CITY PLANNING COMMISSION

APPLICATION: 1. Environmental Determination
2. Tentative Map to resubdivide an 8.6± acre parcel of vacant land into 40 single family lots in the Single Family (R-1) zone.

LOCATION: West side of Carlin Avenue, south of Ehrhardt Avenue

83-298

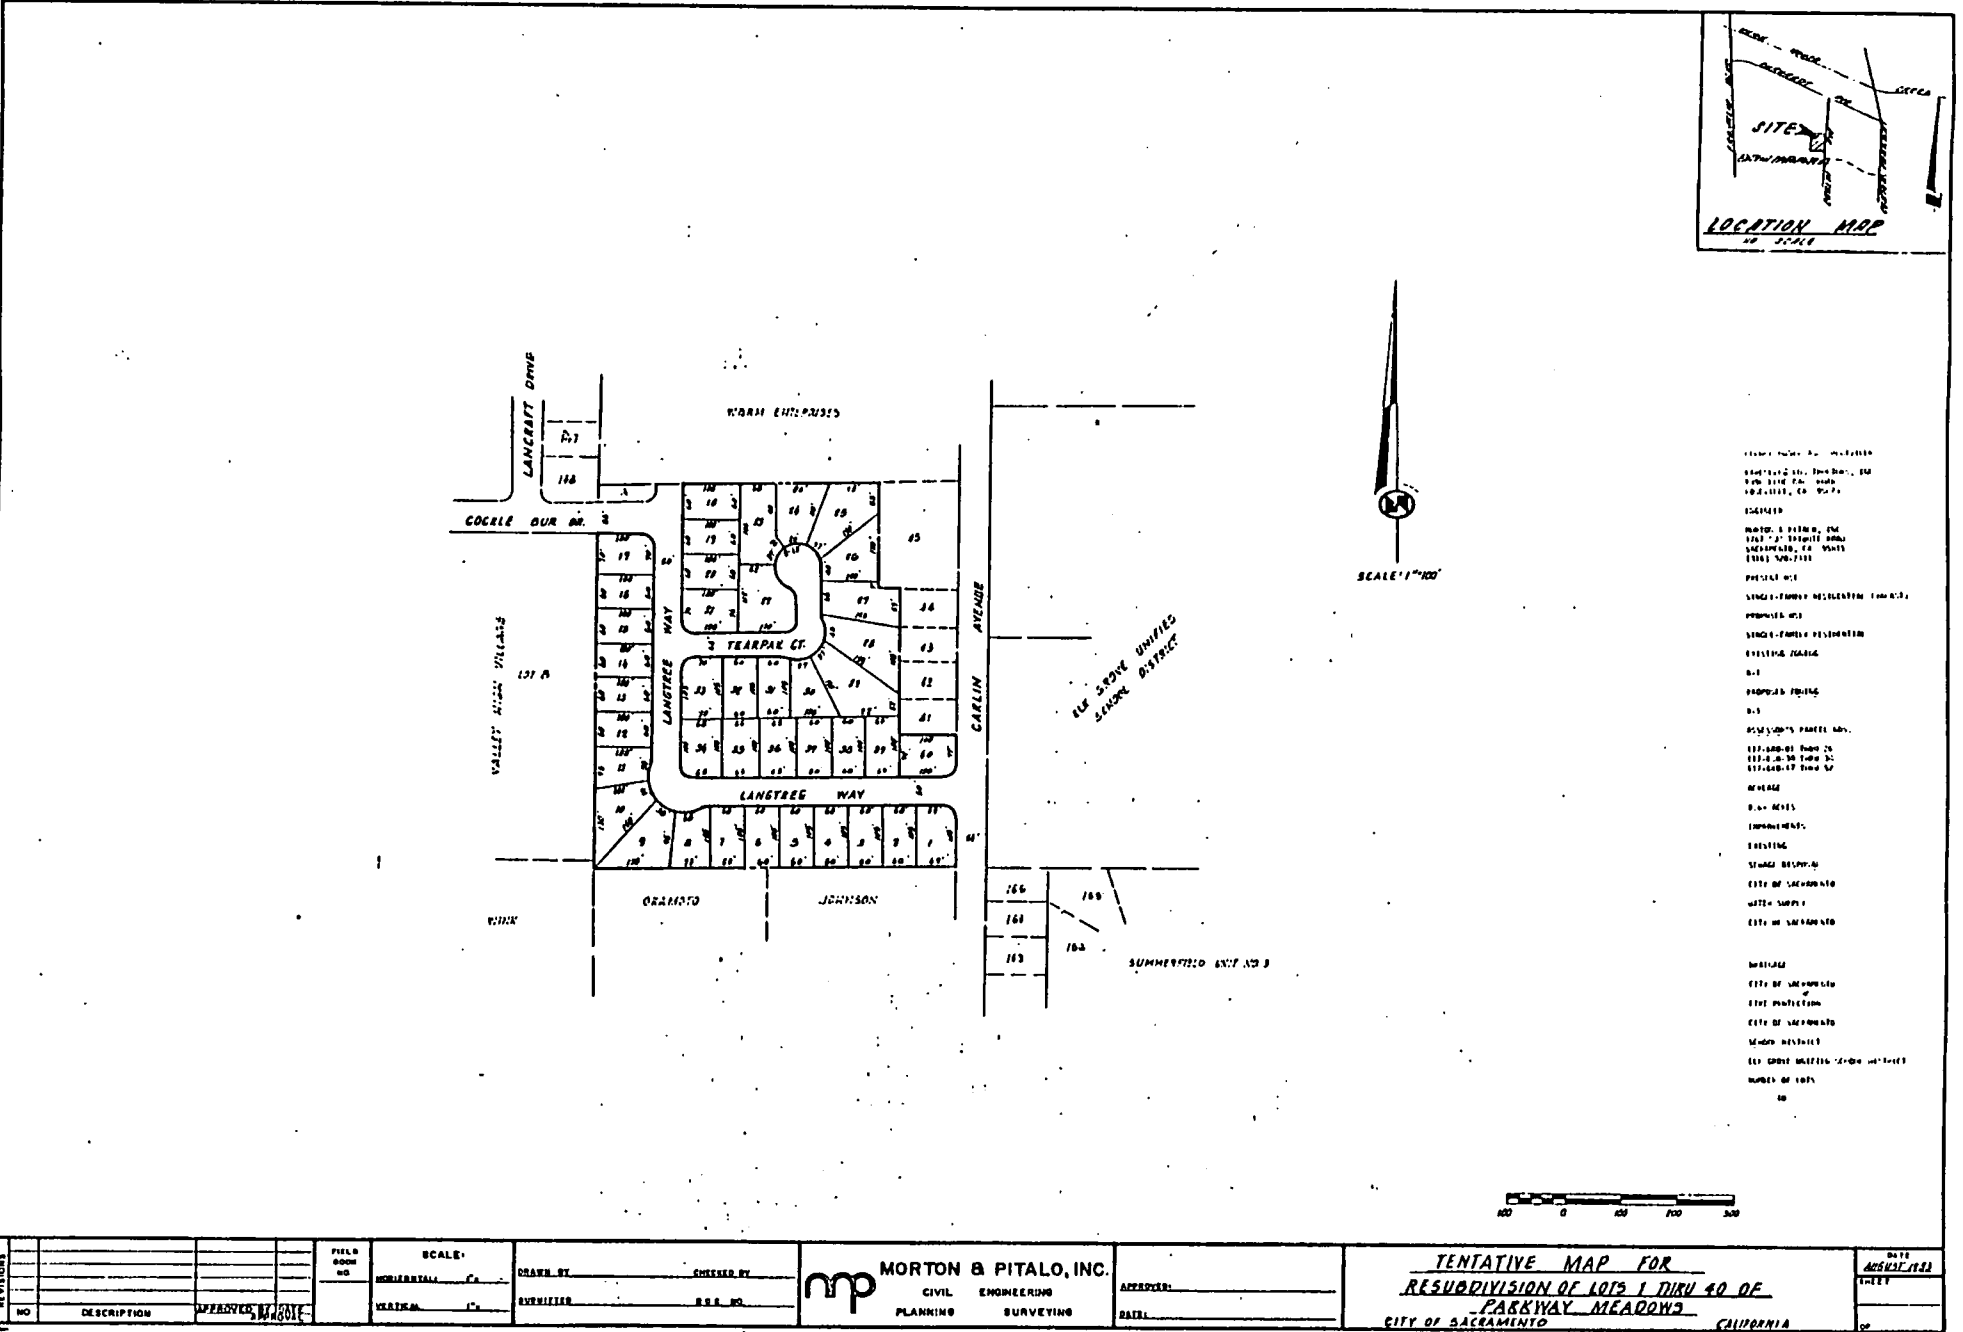
3. The site plan indicates that only 52 percent of the lots achieve the required 80 percent north/south lot orientation for solar access. The applicant will be required to achieve the necessary solar access through structure orientation or south wall window glazing on 28 percent of the lots.

4. The site is currently developed with standard subdivision improvements; however, the street lights, fire hydrants, water and sewer service do not conform to the proposed property lines and will, therefore, require relocation or modification.

- c. The applicant/developer shall designate and place on the final map those structures and/or lots which will meet the required eighty percent (80%) south orientation (including solar access) to the satisfaction of the Planning Director;

- d. Street lights and fire hydrants must be relocated to new property lines as required by the City Engineer;
 - e. Locate existing sewer and water services and relocate or construct such services as required (possible key cutting and one-inch curbing may be required).
